ADDENDUM NO. 1

September 14, 2026

**Perry Meridian High School Phase 2 Renovations
401 W. Meridian School Road
Indianapolis, IN 46217**

UNIT D PARTIAL PLAN

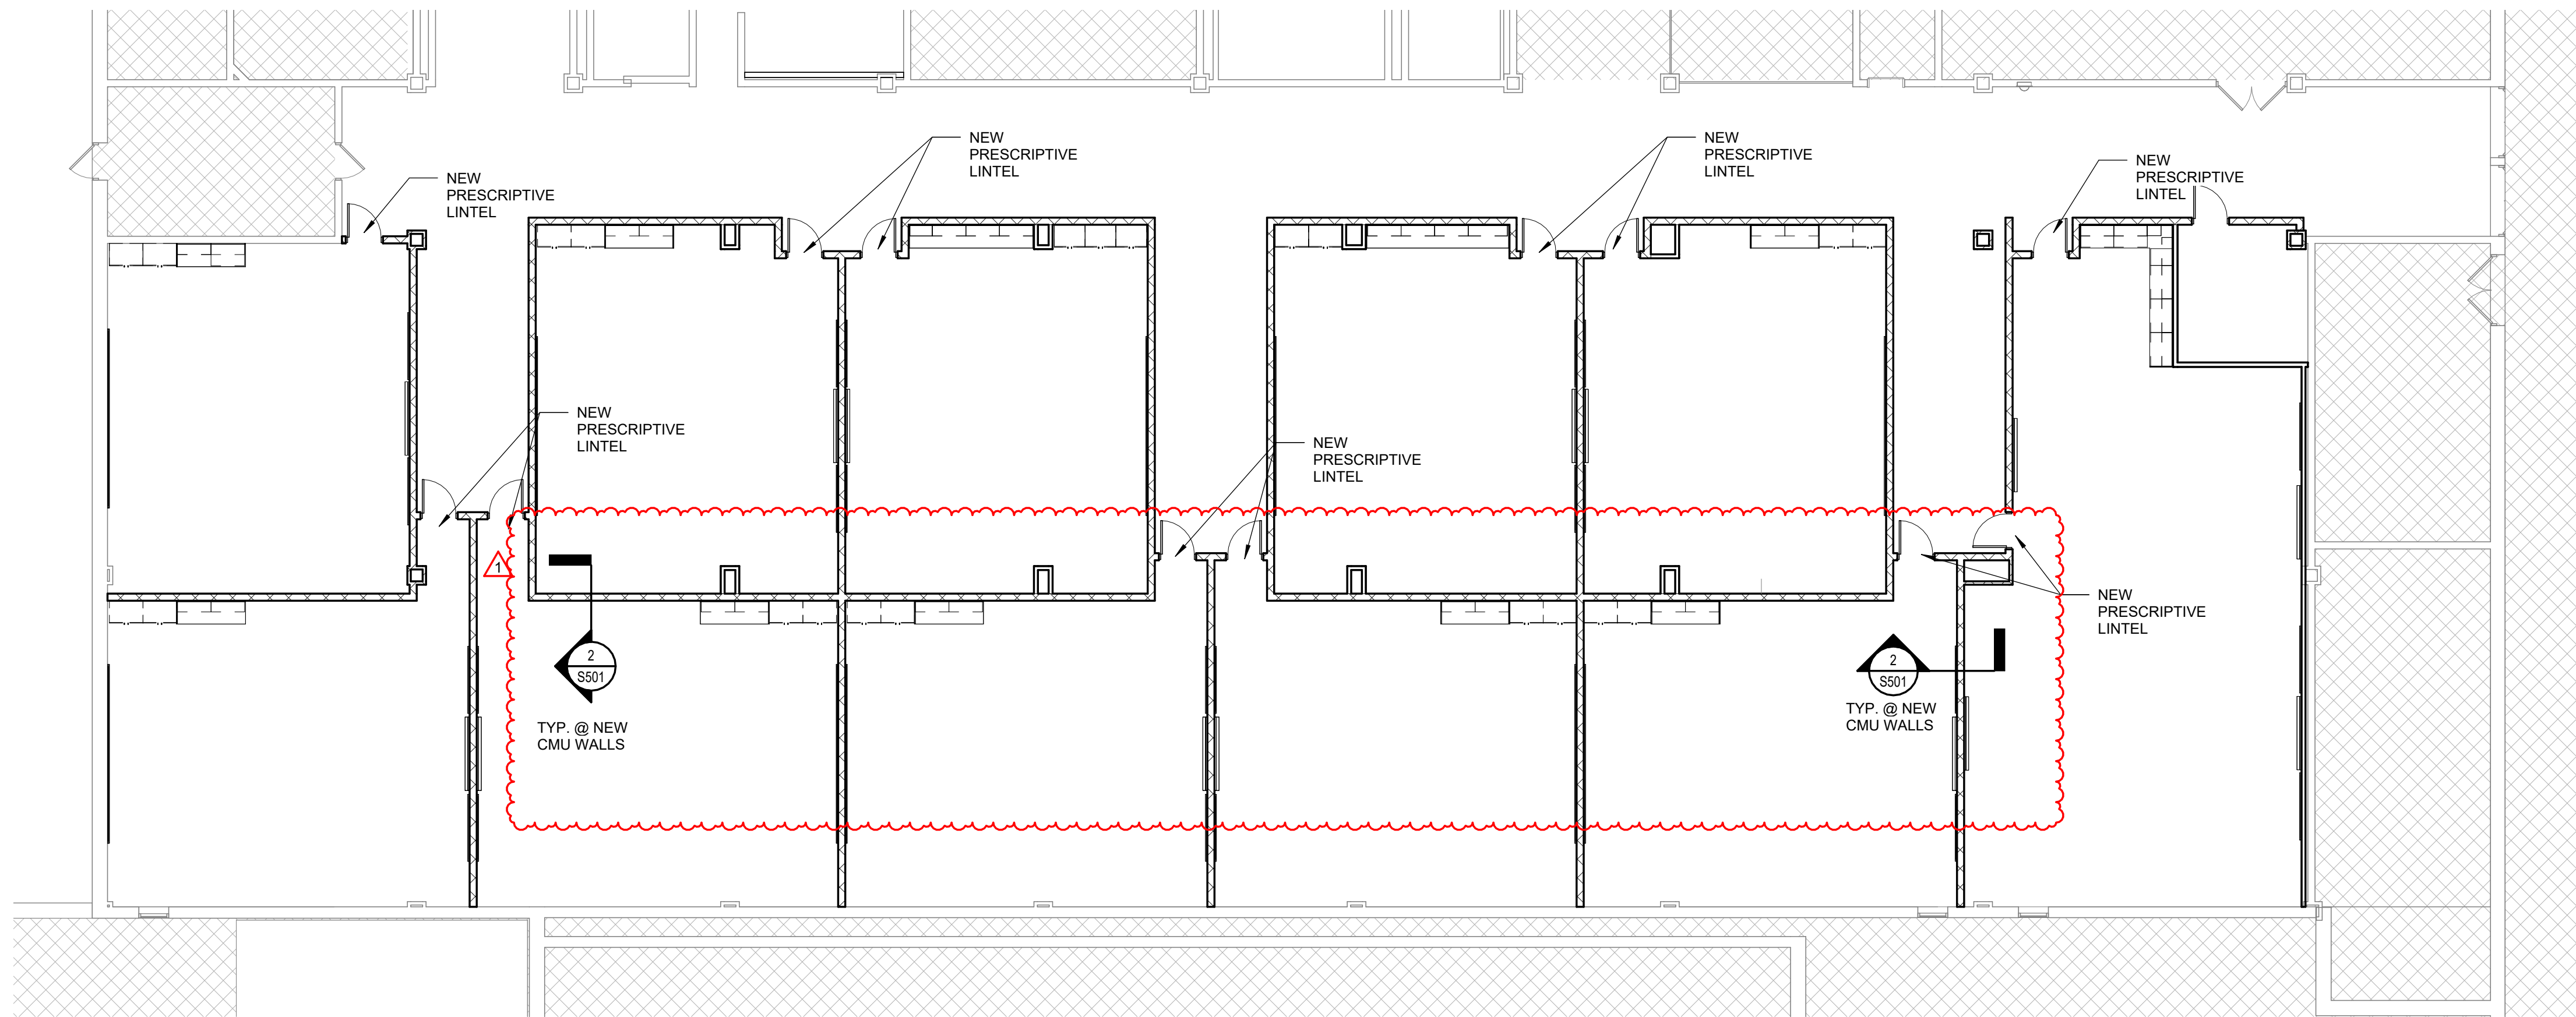
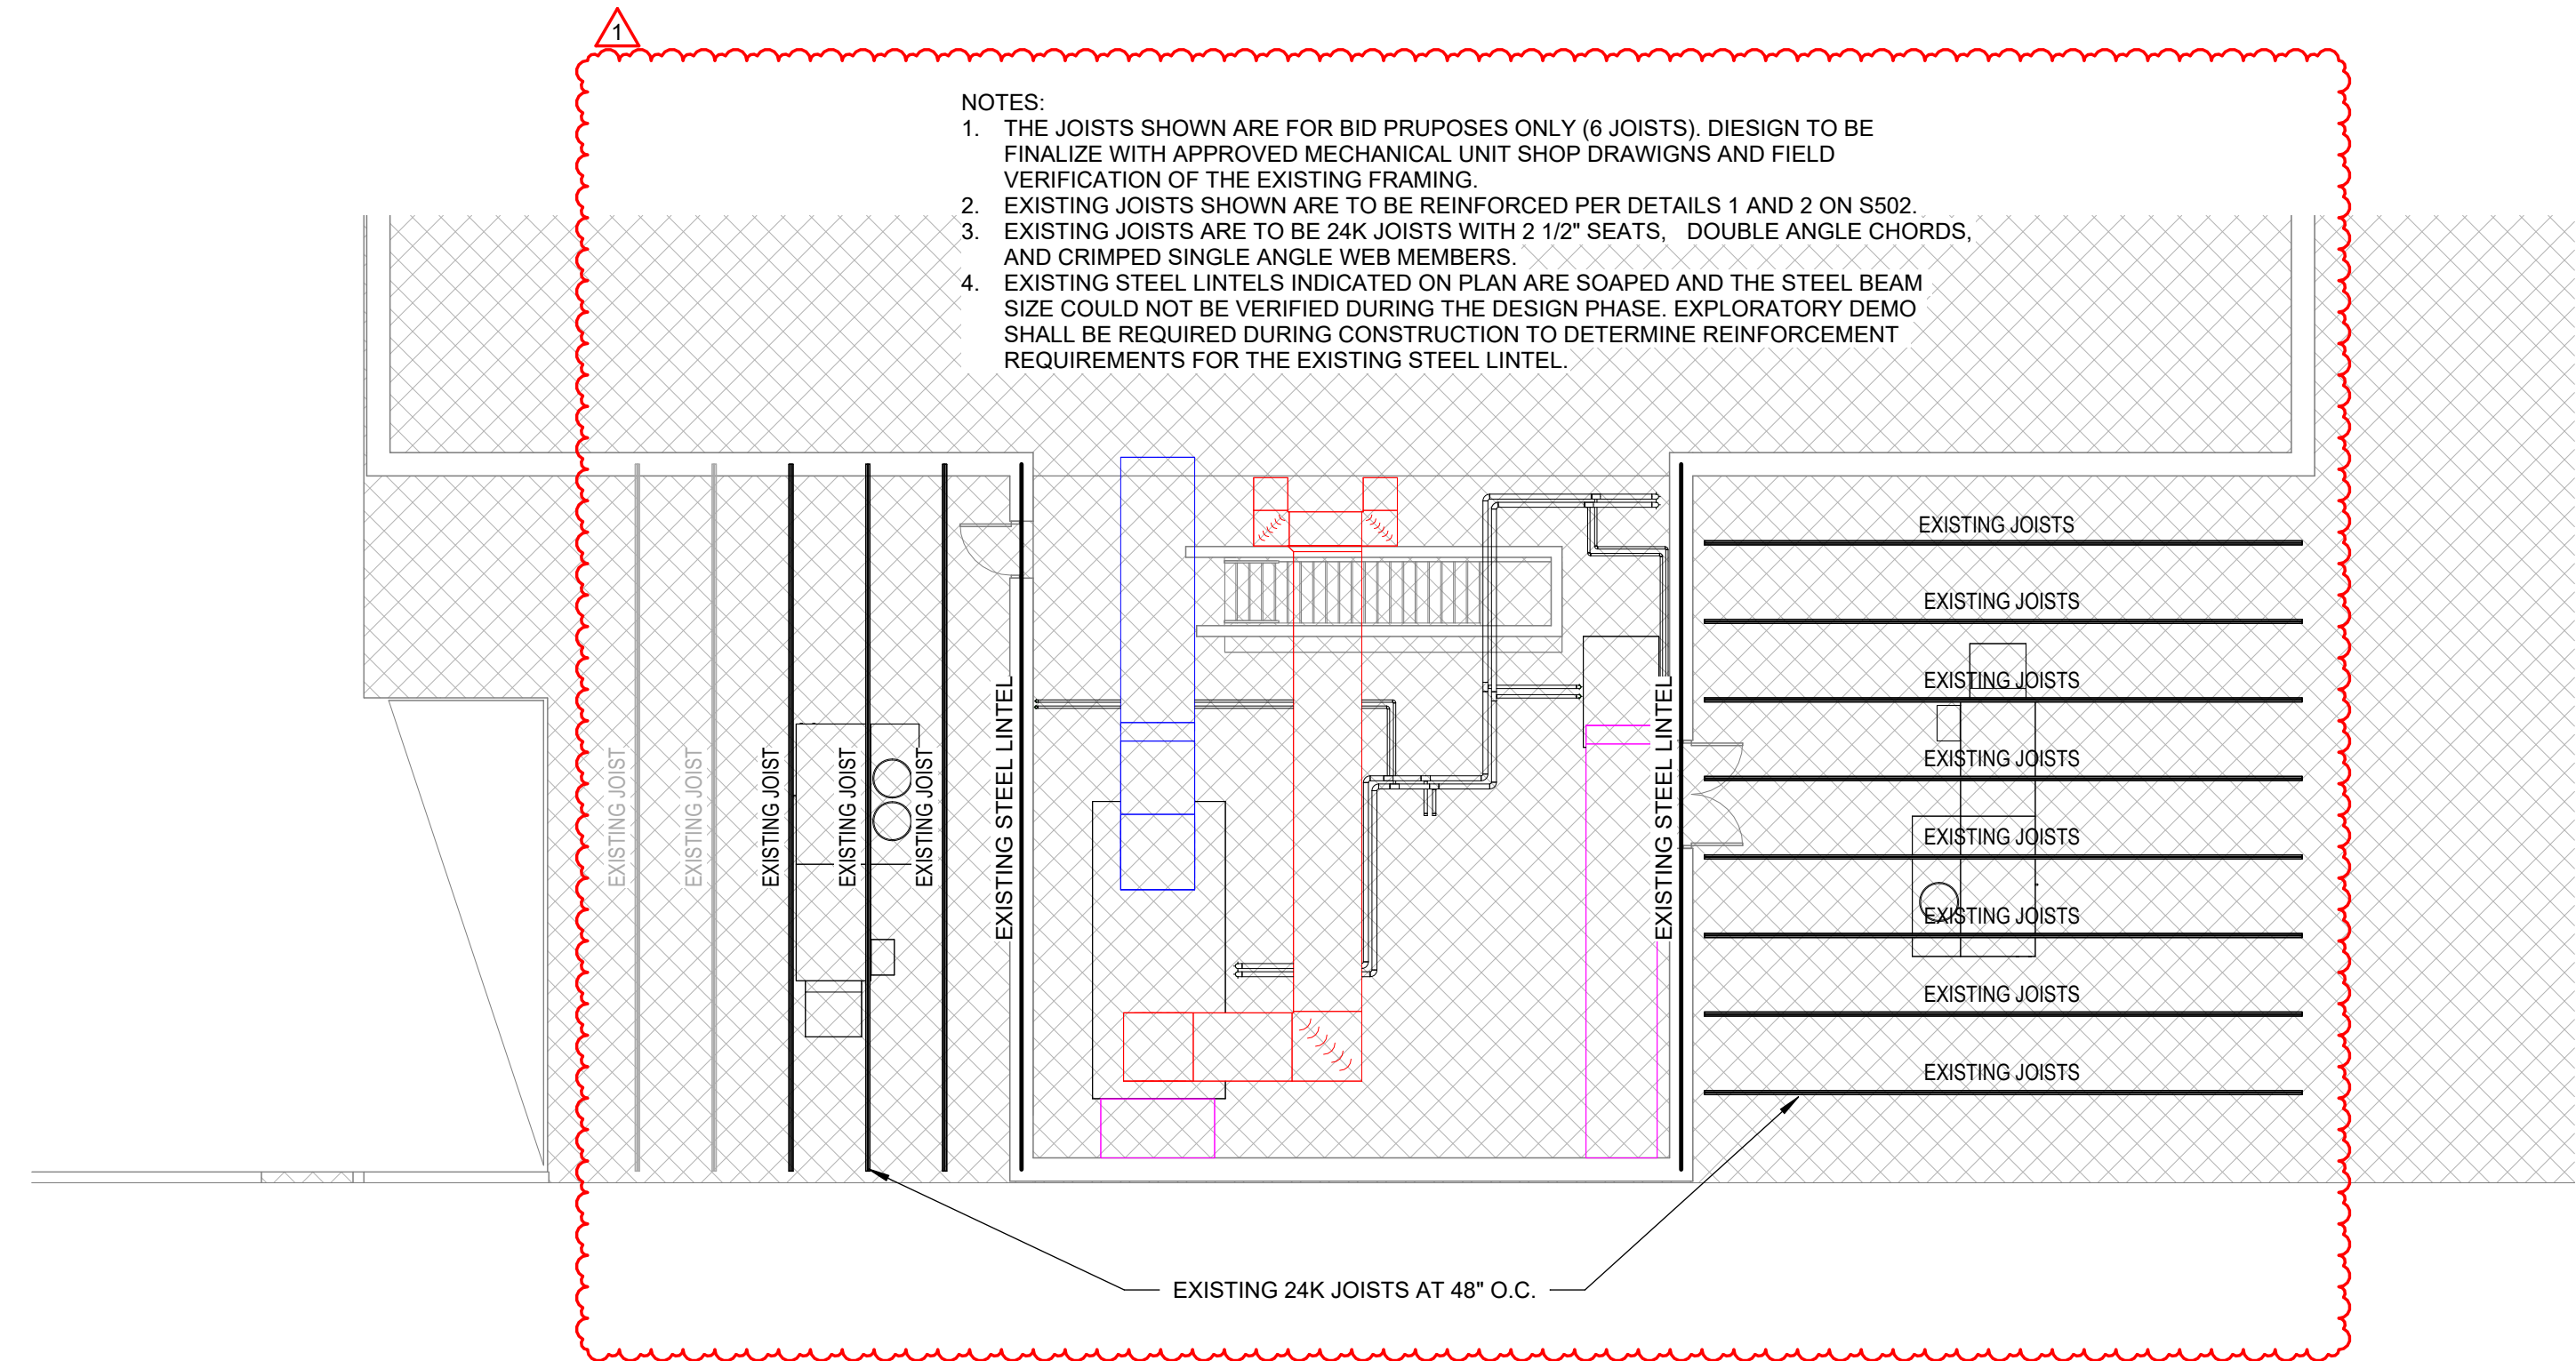
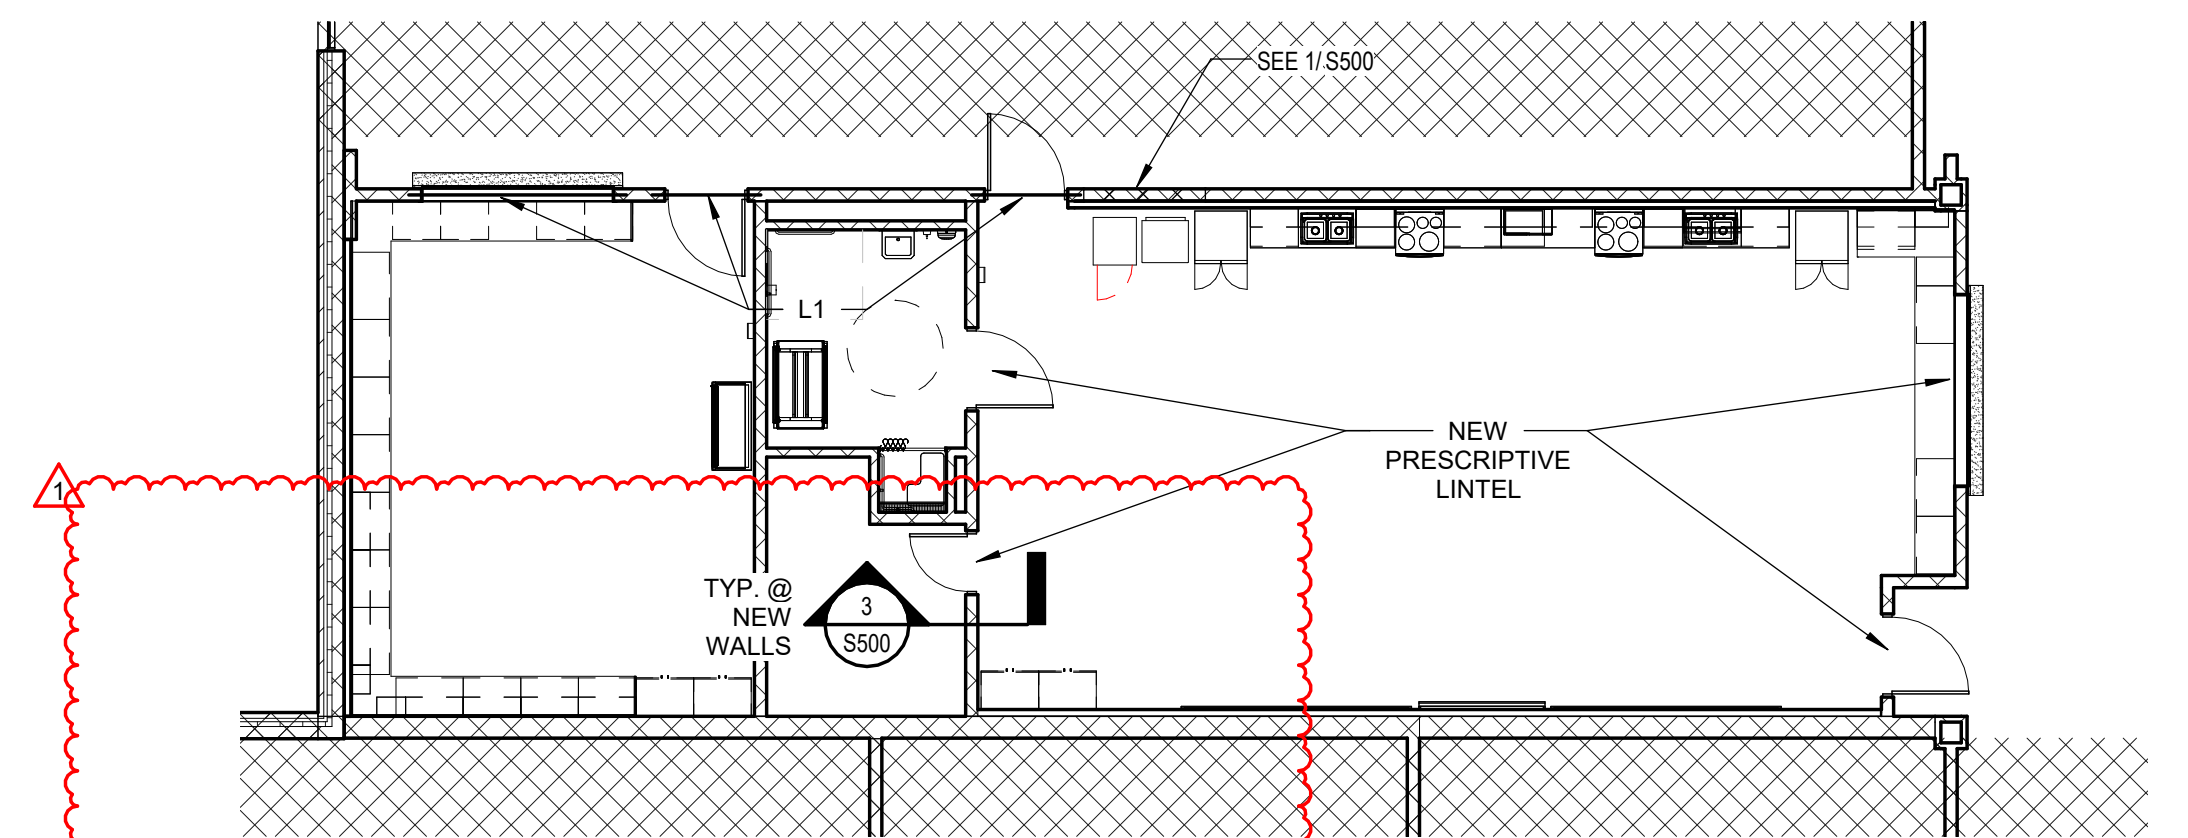
5. **Q:** Note 2 listed in Unit G Partial Structural Plan on sheet S101 states per detail X/X. Please update with detail/sheet and provide said detail/sheet (S502?)

7. Drawing Sheet Number: S101
Drawing Sheet Title: PARTIAL PLANS

- Added slab and section cuts to Unit D PARTIAL PLAN.
- Added section cuts to Unit B and F PARTIAL PLANS.
- Revised plan note 2 and added plan note 3 to PARTIAL PLAN NOTES.
- Revised partial framing to reflect existing conditions and revised plan notes for Unit G.

- a. See attached revised structural drawings in addendum 001.
6. **Q:** Roofing plans include elevation and section call outs for interiors. These are not relevant and should be removed.
